REMARKS

Claims 1-22 are currently pending. The Applicant is herein amending claims 1-3 and 8-22. The Applicant notes that the amendments are not intended as narrowing amendments. Rather, the amendments are intended to broaden or maintain the scope of the originally filed claims.

FIG. 1

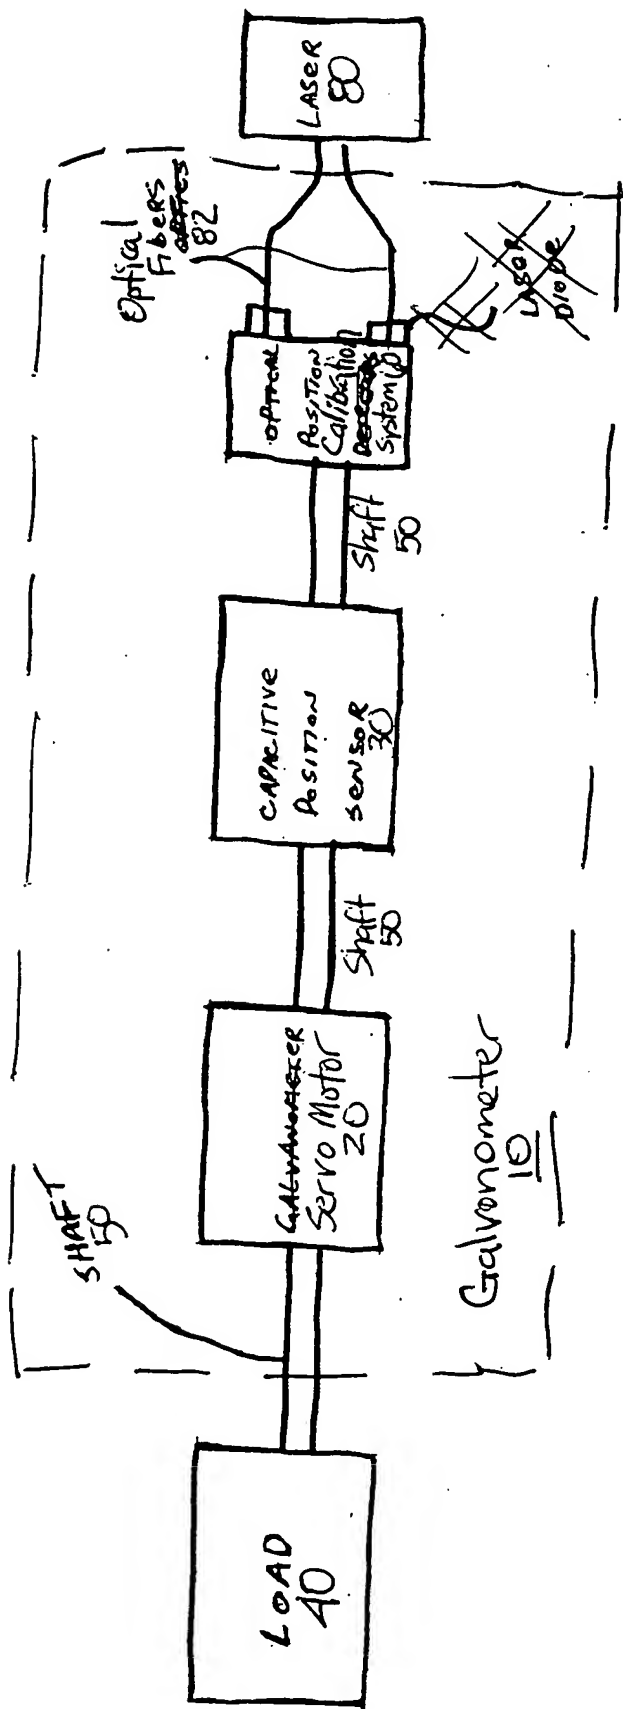
The Examiner objected to the Figure 1-3, and requested that the reference numbers used to describe the Figures be added to the Figures. The Applicant has amended the Figures 1-3 accordingly. As such, the Applicant respectfully requests the examiner to withdraw this objection. The Applicant further notes that formalized drawings will be provided upon the Examiner's approval.

Fig 4

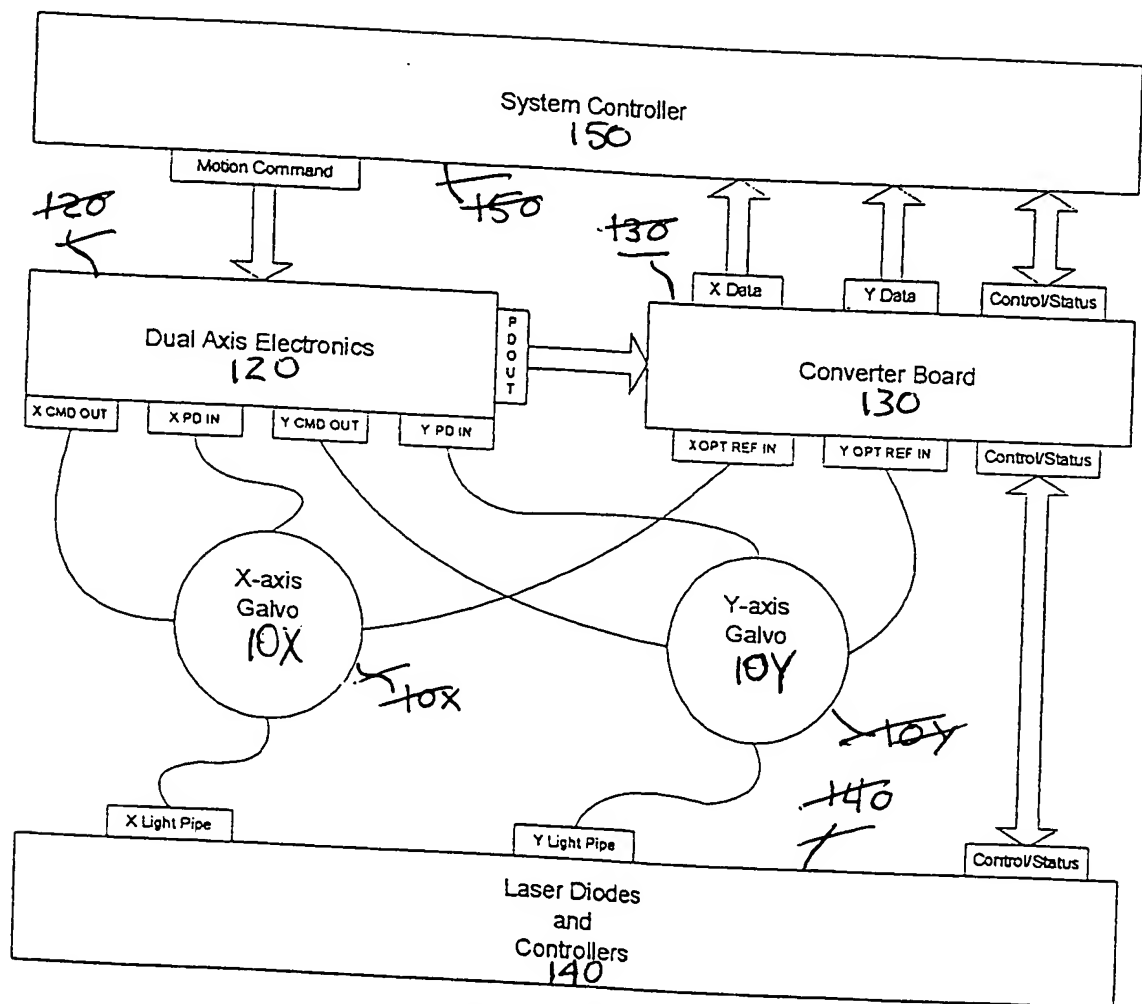
The Examiner objected to Figure 4 for including certain reference labels not expressly mentioned in the detailed description. The Applicant has amended to the detailed description at pages 17 and 18 to expressly state the noted reference labels in appropriate locations as indicated in the "Amendments to the Specification" section of this response. As such, the Applicant respectfully requests the examiner to withdraw this objection.
